## DRAFT AMENDMENT C244 MELTON EAST PRECINCT STRUCTURE PLAN SUBMISSION

Veris acts on behalf of Maximise Group (Maximise), the owners of the land at 2231-2257 Melton Highway (the site) within the Melton East Precinct Structure Plan (PSP). The below sets out Maximise Group's formal submission to the release of draft Planning Scheme Amendment C244 that is intended to implement the Melton East PSP. The submission responds to key identified issues and constraints.

**SUBJECT: DRAFT AMENDMENT C244 MELTON EAST PRECINCT STRUCTURE PLAN  
SUBMISSION | SEWER AND DRAINAGE STRATEGY**

Melton East PSP - Altered Tarletons Road Alignment  
Concept Layout Plan - Signalised Intersection

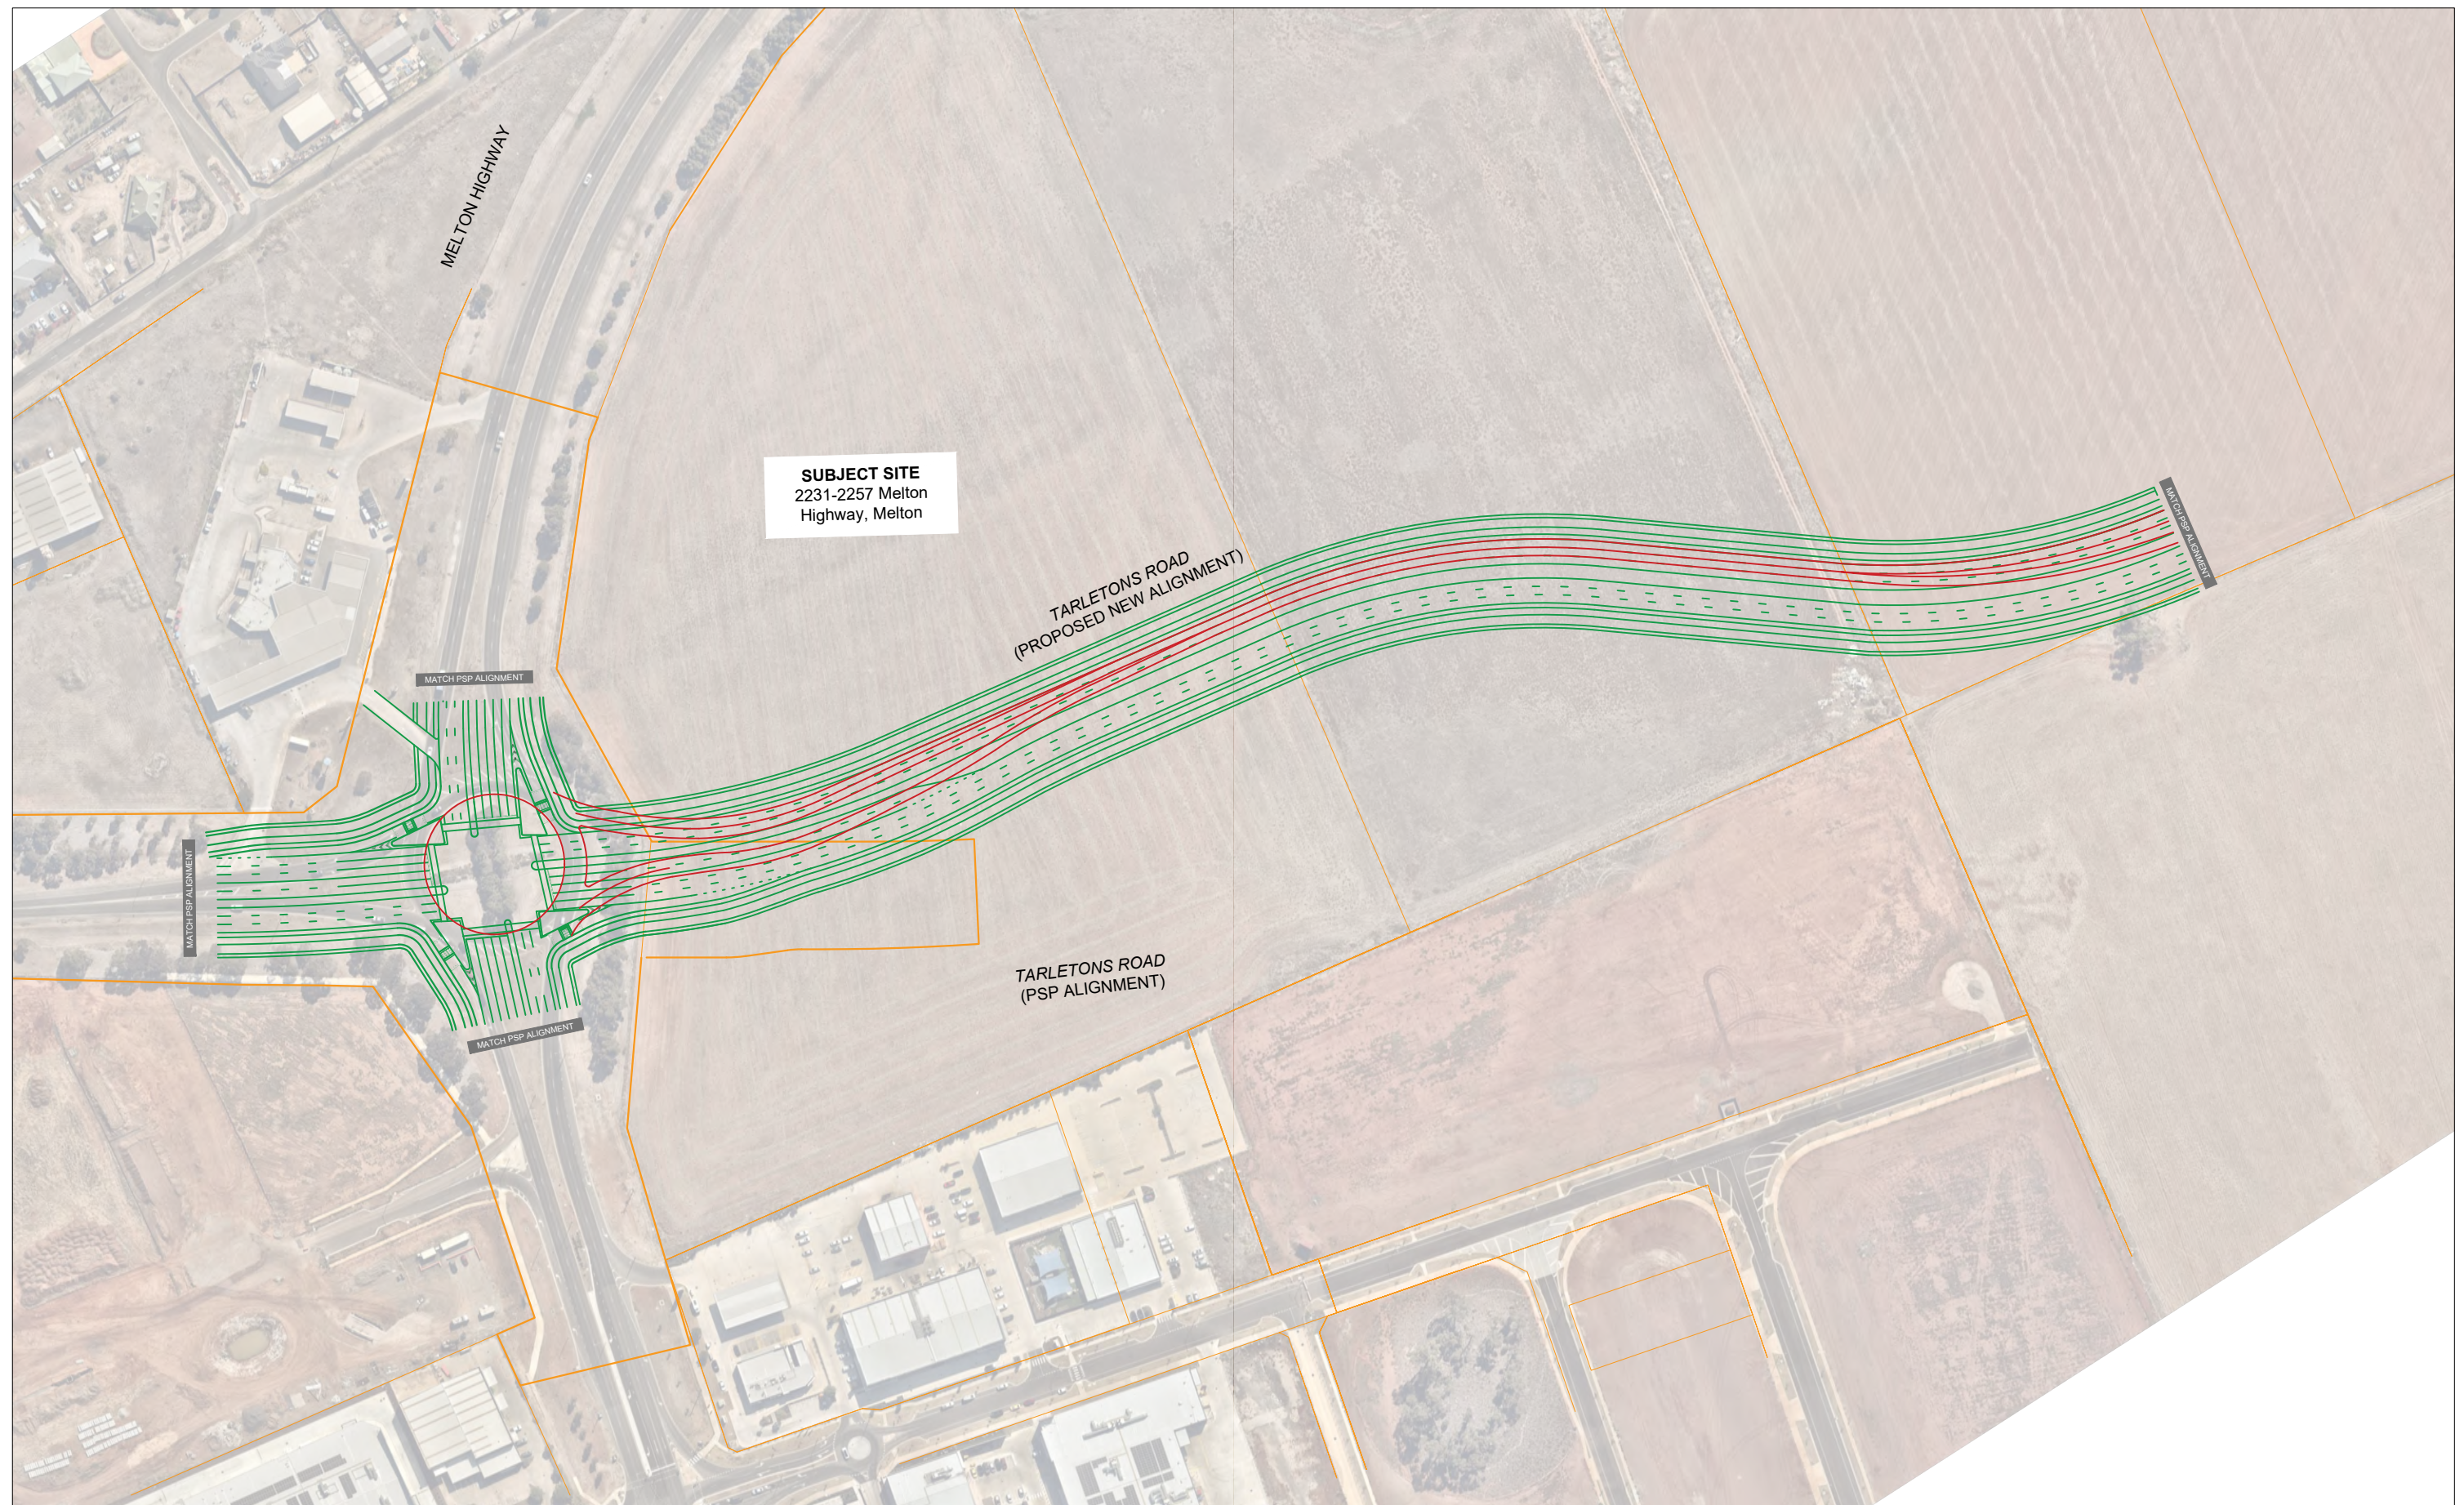
- Tarletons Road upgrade including IN-04 (signalised intersection) and RD-02-01 will be delivered in the interim as a 2-lane arterial road with a connection to the existing roundabout at Melton Highway. The Melton East ICP includes interim construction of both infrastructure projects however the ICP states that interim works are not considered eligible for works in kind credits. If the subject site is developed first, the interim roundabout connection would need to be delivered, likely as works in kind. We submit that works in kind credit should be permitted in this instance if required. We also require further clarity as to whether DTP will fund the ultimate construction of these infrastructure projects.

1. East-west curved alignment based on design criteria for in AustRoads GTRD Part 3 - Geometric Design.

**2231-2257 Melton Highway, Melton**  
Melton East PSP - Altered Tarletons Road Alignment  
Concept Layout Plan - Interim Roundabout  
Connection

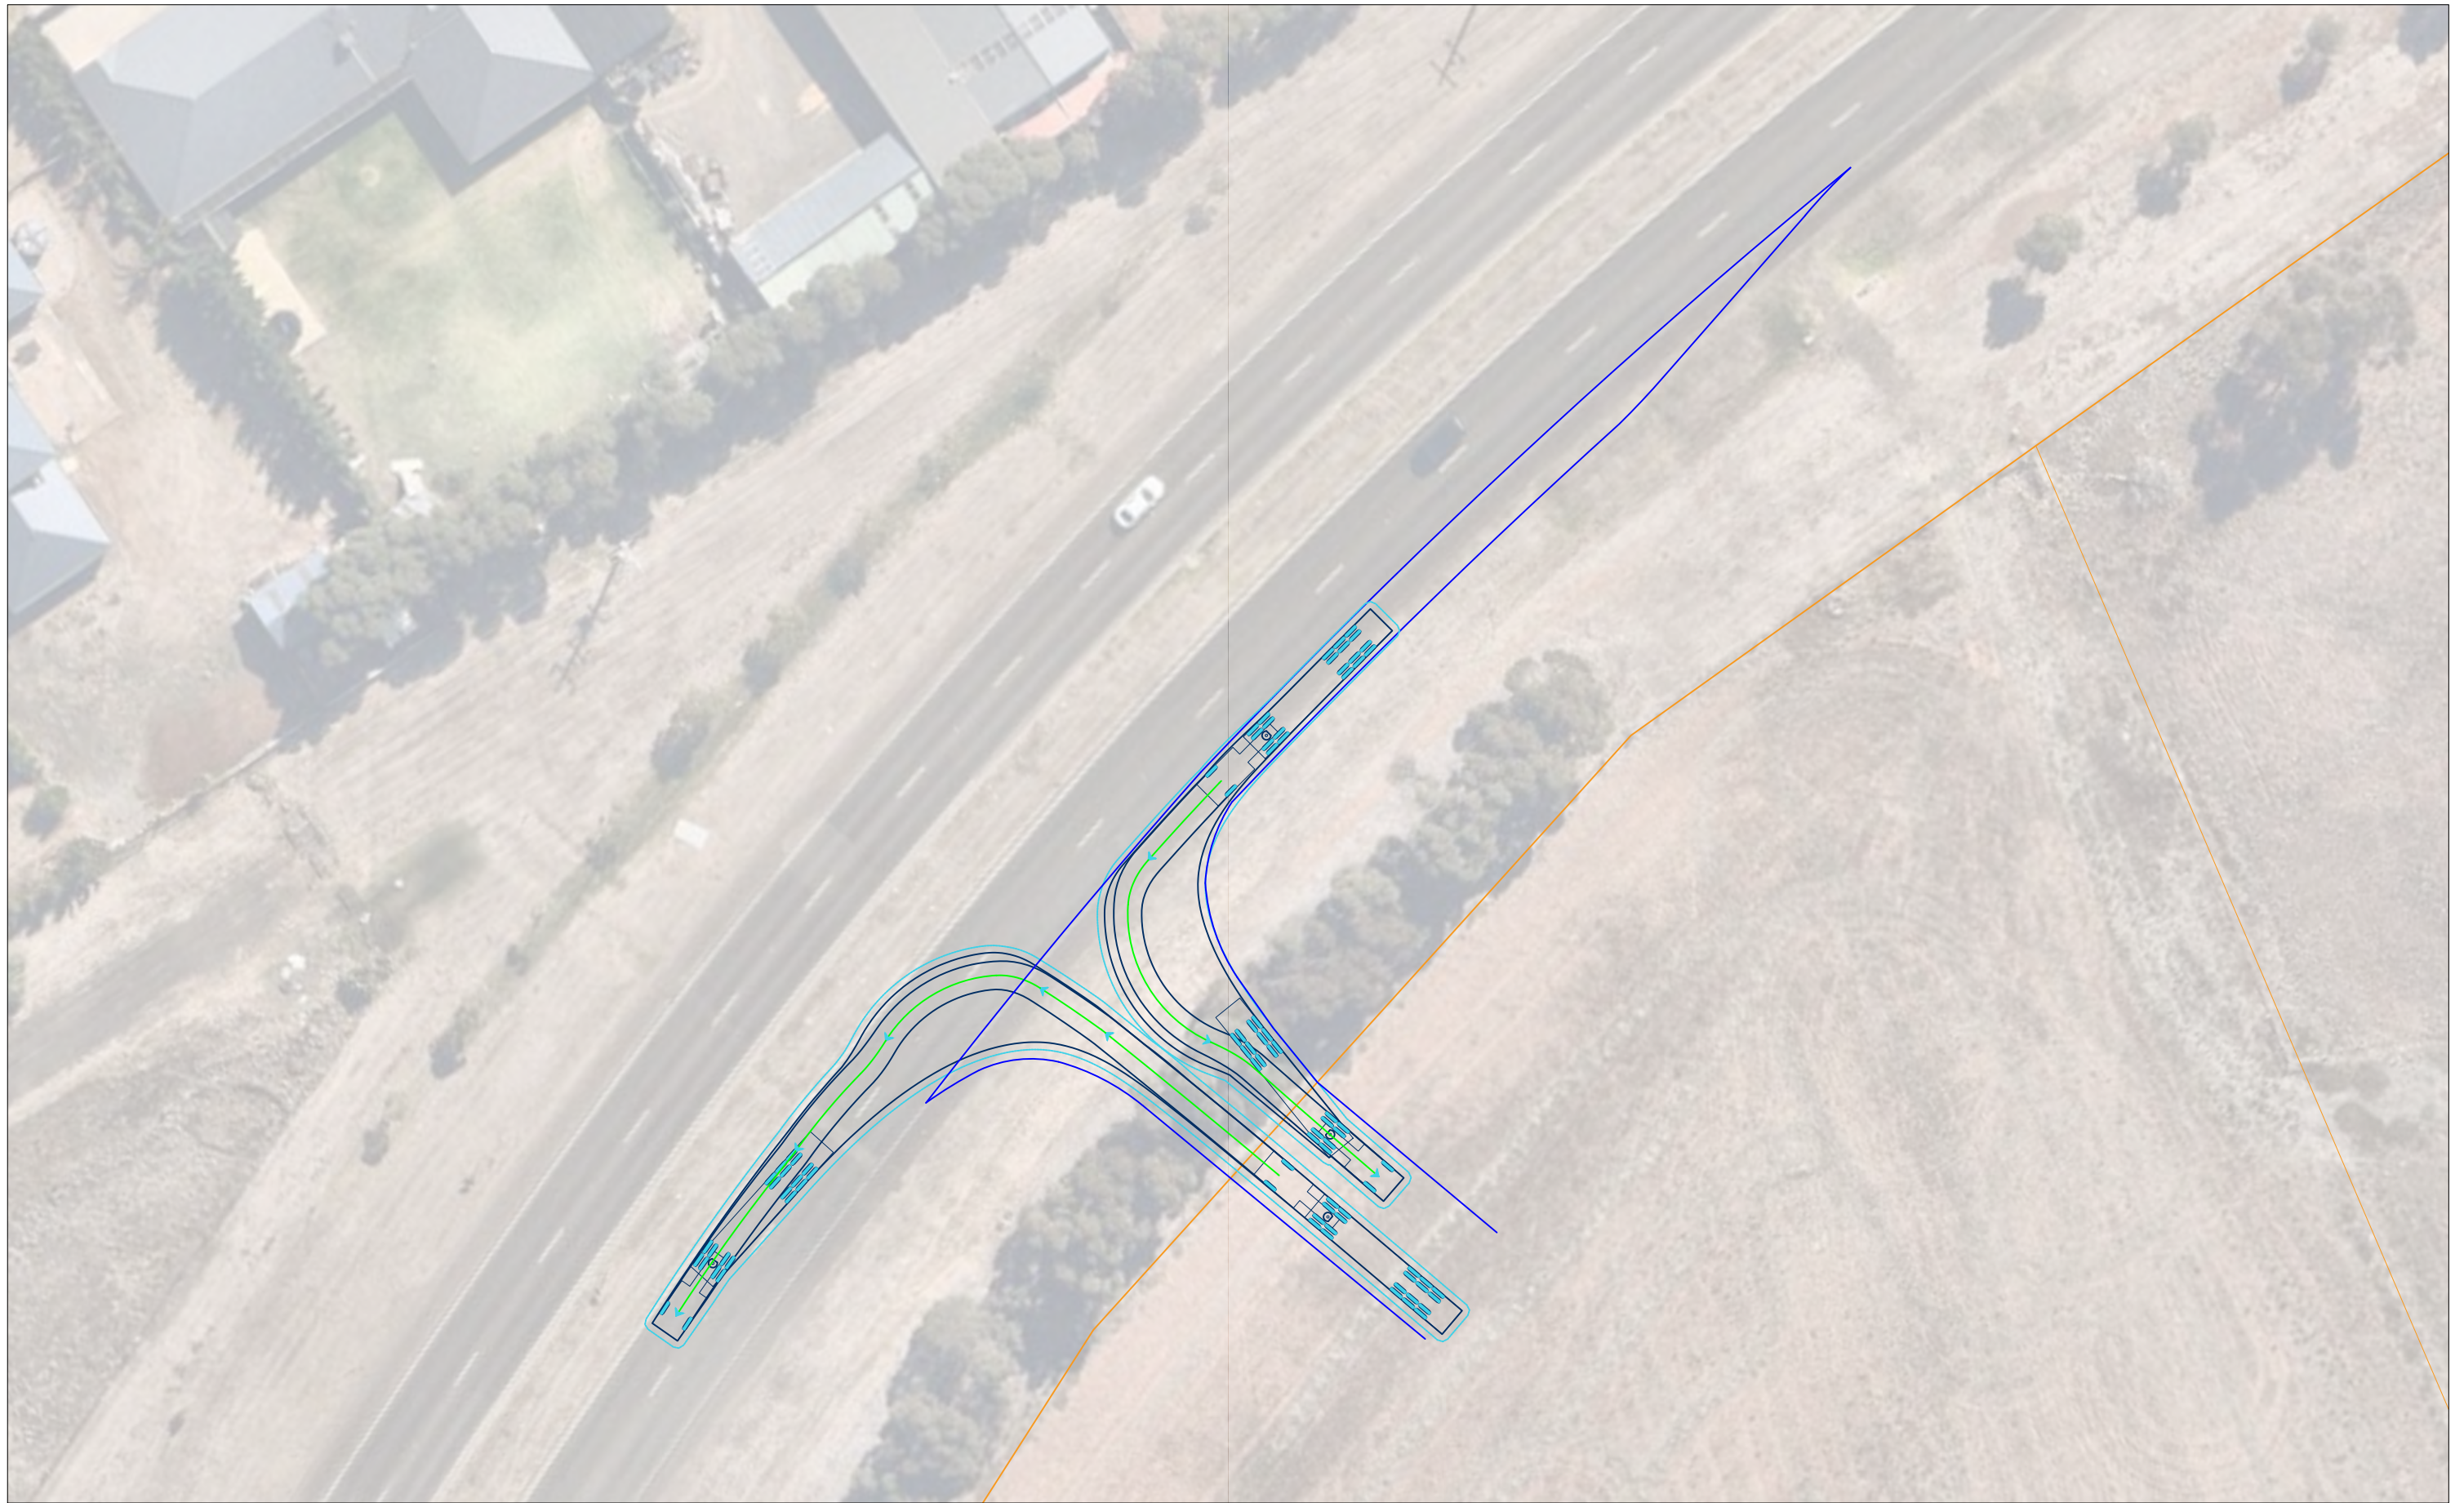
ICP states that no works in kind credits can be sought for interim works, unless agreed by the collecting and development agencies.	<p>anyway however we require confirmation that works in kind credits may be sought by the developer for the interim roundabout connection.</p> <ul style="list-style-type: none"> <li>The ultimate construction of IN-04 and RD-02-01 is not included within Melton East ICP. We require confirmation that DTP will be responsible for funding the ultimate construction of these projects. Assuming DTP funding, Maximise's preference is to develop the final solution in one go to avoid duplication of works.</li> </ul>
<b>6-lane cross section for Tarletons Road</b>	Tarletons Road is nominated as primary 6-lane arterial between Melton Highway and Mount Cottrell Road.	<ul style="list-style-type: none"> <li>Another concern is the proposed six-lane cross-section for Tarletons Road, specifically between Melton Highway and Mount Cottrell Road. This section of the road has been designated as a six-lane corridor, yet the findings of the Integrated Transport Assessment prepared by AECOM (February 2025) suggest that a four-lane cross-section would suffice to meet the projected traffic demands. Section 7.1.4 of the ITA highlights that the strategic VITM modelling indicates no need for the additional capacity provided by a six-lane design. The justification that it may offer an advantage for reducing bus delays is unsubstantiated.</li> <li>The concerns arising from this potential over-design include unnecessary land acquisition, higher infrastructure costs, impacts pedestrian and cyclist safety (due to longer crossing distances and higher speeds) and more severe urban heat island effects.</li> <li>Another significant concern is that the current analysis relies exclusively on strategic-level modelling using the Victorian Integrated Transport Model (VITM). While VITM is useful for understanding macro-level traffic demand and broader network connectivity, it does not assess the operational capacity of individual intersections.</li> <li>Specifically, no micro-analytical modelling has been undertaken (e.g. using SIDRA) for the critical intersection at Melton Highway and Tarletons Road. This would inform whether a 6-lane cross-section is actually necessary, or whether it could be provided only on the approach and/or departure of the intersection, merging into a 4-lane cross-section east of Melton Highway. We are of the understanding that the VPA has used SIDRA in the past for examining intersections on other PSP projects, for example the East Werribee PSP.</li> <li>Given these concerns, it is recommended that the VPA undertake further detailed analysis before finalising the road network design for Tarletons Road. This includes SIDRA modelling to inform the actual lane requirements and whether a 4-lane cross-section could be adopted for all or part of Tarletons Road, east of Melton Highway.</li> <li>Incorporating detailed operational analysis will ensure that the road network design is proportionate to actual traffic needs, efficient in terms of cost and land use, and conducive to a safer and more walkable environment for future residents and others.</li> </ul>

1. East-west curved alignment based on design criteria for in AustRoads GTRD Part 3 - Geometric Design.
